Subject: Design Plan - Additional Explanation
Nursery Products Hawes Composting Facility

COUNTY OF SAN BERNARDINO ON-SITE HYDROLOGY MAP NURSERY PRODUCTS HAWES COMPOSTING FACILITY

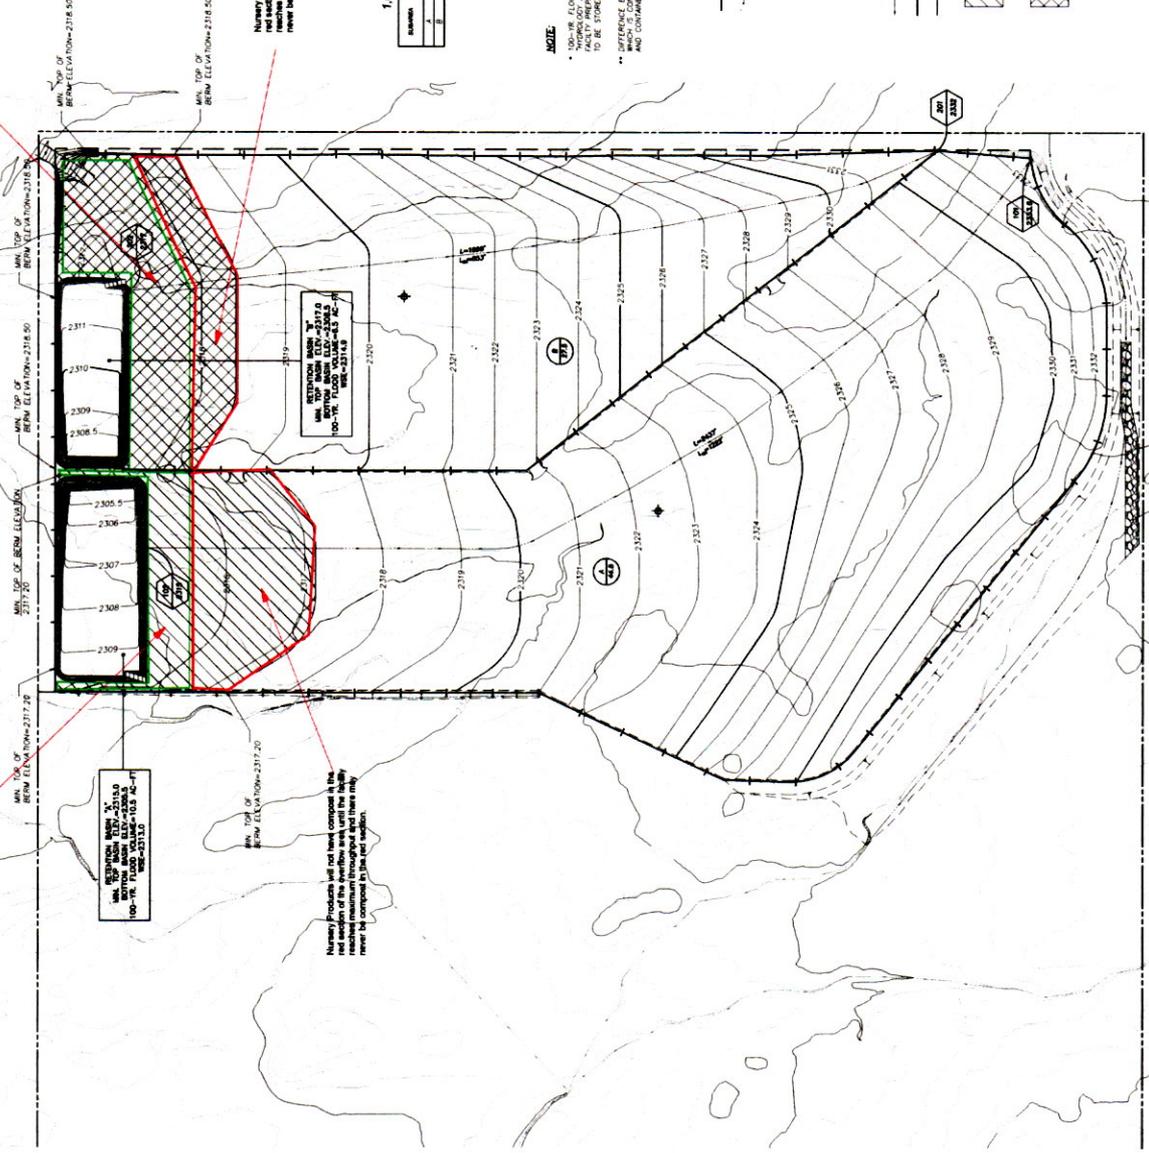
On August 13, 2010, Nursery Products submitted the Design Plan Addendum in response to comments from the California Regional Water Quality Control Board, Lahontan Region (Water Board) received in July, 2010. On October 7, 2010 the Water Board submitted comments on the *Design Plan Addendum*, which requested additional information in regard to the overflow area at the Nursery Products Hawes compost facility (Facility). On October 14, 2010 Nursery Products submitted additional explanation of the Design Plan Addendum clarifying that all the structures and equipment that will be located in the 'overflow' area are mobile and that any vehicles, tanks, onsite equipment, compost and the temporary office could be relocated out of the overflow area readily and promptly. On October 20, 2010 by telephone the Water Board requested additional information regarding any compost that might be located in the overflow area at the time of a 1000-year, 24-hour storm event.

The 'overflow' area is the last physical area of the Facility where compost will be located. Hence this area will only contain compost when the facility is operating at full capacity. At most the 'overflow' area could contain 17,000 cubic yards of compost, which is approximately four percent of the expected annual maximum throughput. In the unlikely event that a 100-year, 24 hour storm occurs when the Facility is operating at full capacity, the compost in the 'overflow' area can easily and readily be re-located to other portions of the Facility. Attached to this letter is the Hydrology Map of the Facility showing the 'overflow' area. Functionally, the 'overflow' area is divided into two areas. The attached Map identifies the green section. This area will never under any circumstances contain compost and will be the first area impacted by storm water as a storm exceeds the 100-year, 24-hour storm and may begin to escalate to a 1000-year, 24-hour storm. The red section on the attached Map is the only portion of the 'overflow' where compost could potentially be located when the Facility is at full capacity. It is highly unlikely that compost will be placed in the 'overflow' area. However, if the Facility reaches the maximum throughput compost may be located in the red section of the 'overflow' area. It has been calculated that a maximum of 17,000 cubic yards of compost could be located in the red section. This amount of

compost in windrows would displace 2,843 cubic yards in the red section of the 'overflow' area and this displaced amount was included in the calculations for the Design Plan Addendum.

In addition, any compost in the red section of the 'overflow' area could be removed to the remainder of the site in less than forty-five minutes. A conservative calculation of the time to remove the 17,000 cubic yards of compost from the red area of the 'overflow' area is forty minutes. This calculation is based on six front end loaders with 8 yard buckets each moving 9 loads per minute for a total of 40 minutes. The onsite equipment could move the compost more quickly dependent upon the distance that the compost is being moved. Forty minutes provides a large margin when one recalls that a storm event would need to first surpass the 100 year, 24-hour storm, then surpass the capacity of the green section of the 'overflow' area and only then impact the red section where the compost could be located if the Facility were operating at full capacity. Nursery Products will have ample opportunity to remove any compost in the red section of the overflow area should these storms events occur.

Nursery Products will not have compost in the red section of the overflow area. The green section of the overflow area.

Nursery Products will not have compost in the green section of the overflow area.
